HISTORIC AND DESIGN REVIEW COMMISSION

June 01, 2022

HDRC CASE NO: 2022-282
ADDRESS: 418 BROOKLYN AVE
LEGAL DESCRIPTION: NCB 447 BLK 2 LOT 13 (CAVENDER PH-1)
ZONING: FBZ T6-1, RIO-2
CITY COUNCIL DIST.: 1
APPLICANT: CBMB MAKE- READY LLC
OWNER: CBMB MAKE- READY LLC
TYPE OF WORK: Construction of a retail structure
APPLICATION RECEIVED: May 10, 2022
60-DAY REVIEW: Not applicable due to City Council Emergency Orders
CASE MANAGER: Edward Hall

The applicant is requesting a Certificate of Appropriateness for approval to construct a retail structure to feature a footprint of approximately 180 square feet. The proposed structure will feature a stucco façade, steel windows and a flat roof with a parapet wall.

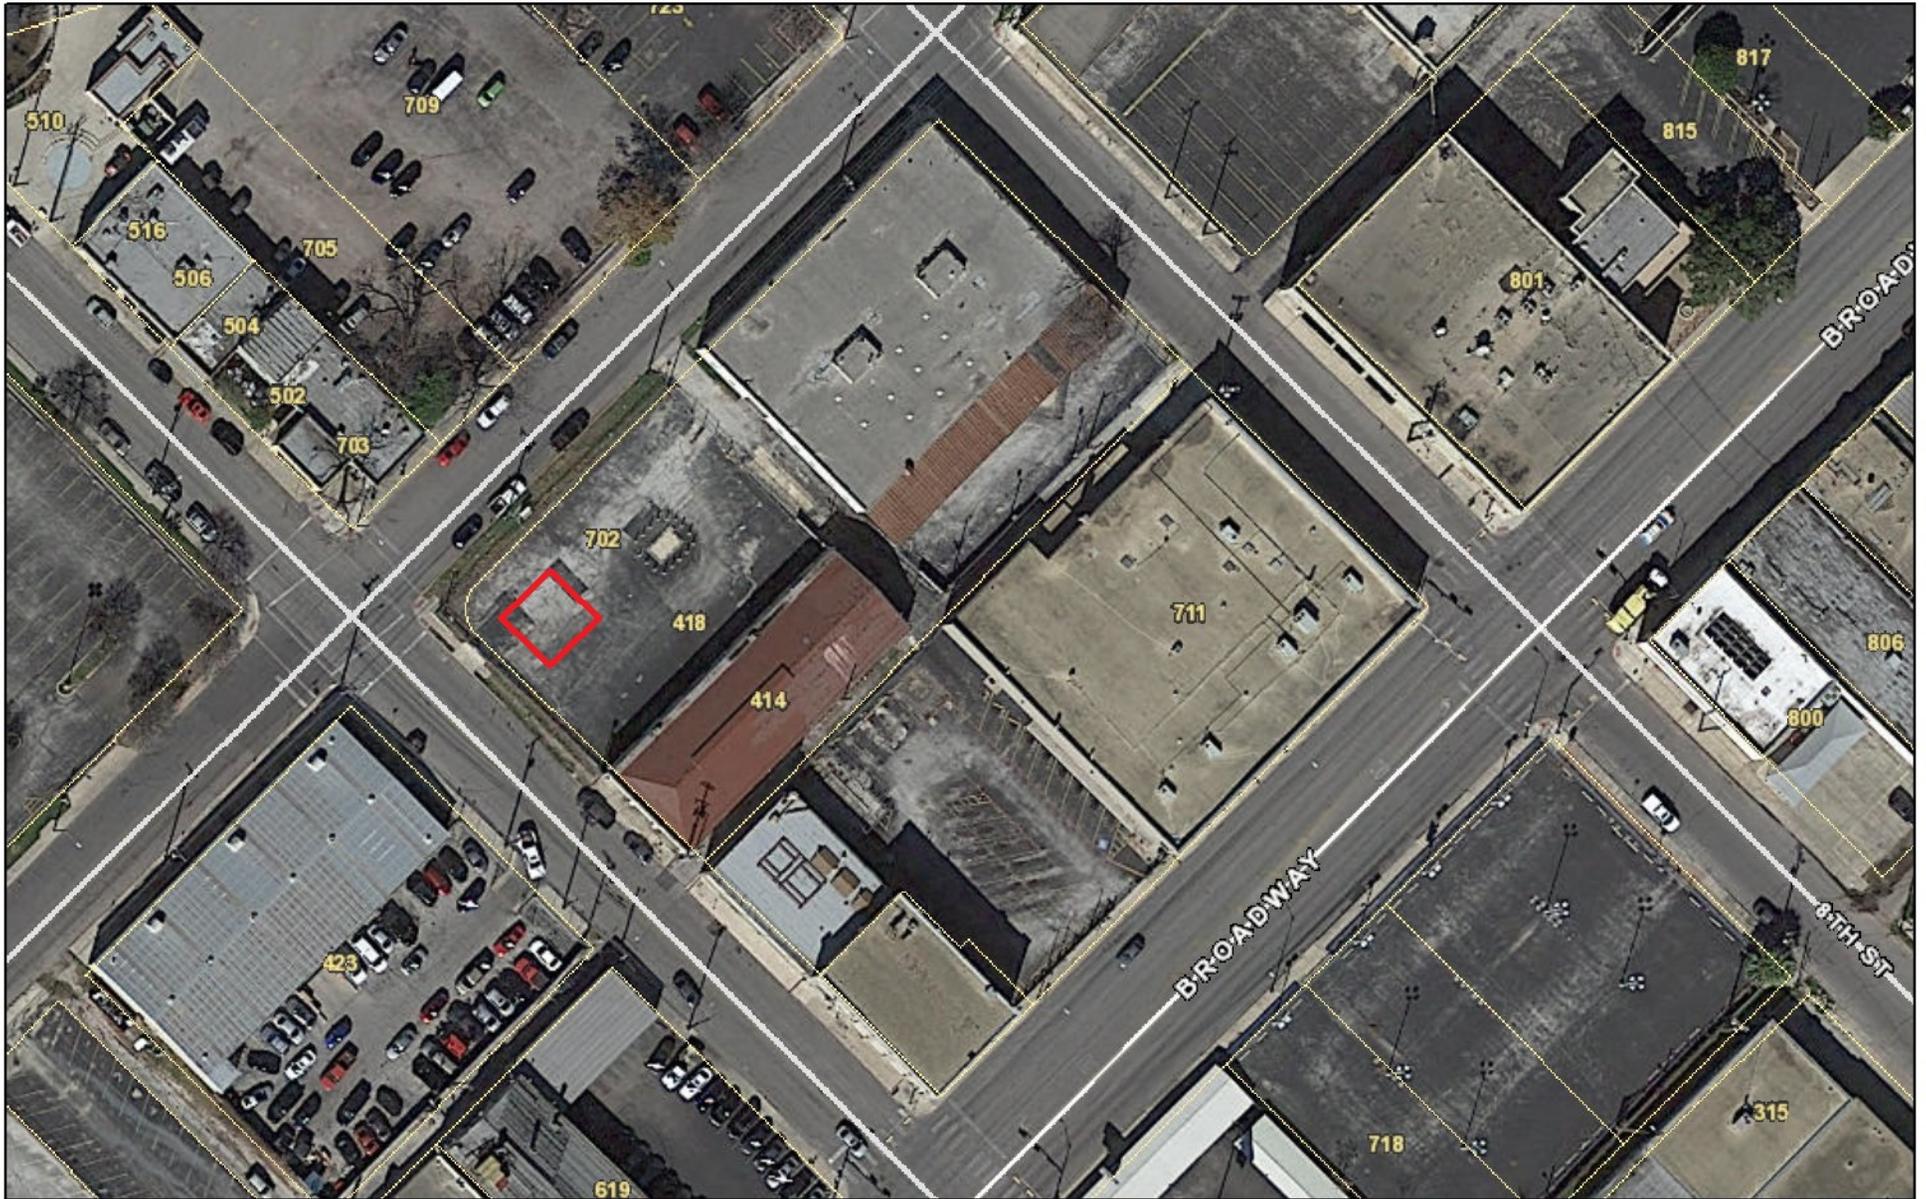
- a. The applicant is requesting a Certificate of Appropriateness for approval to construct a retail structure to feature a footprint of approximately 180 square feet. The proposed structure will feature a stucco façade, steel windows and a flat roof with a parapet wall.

- b. EXISTING SITE – The location of the proposed retail structure is currently occupied by surface parking. Staff finds the construction of a structure at this location to be appropriate.
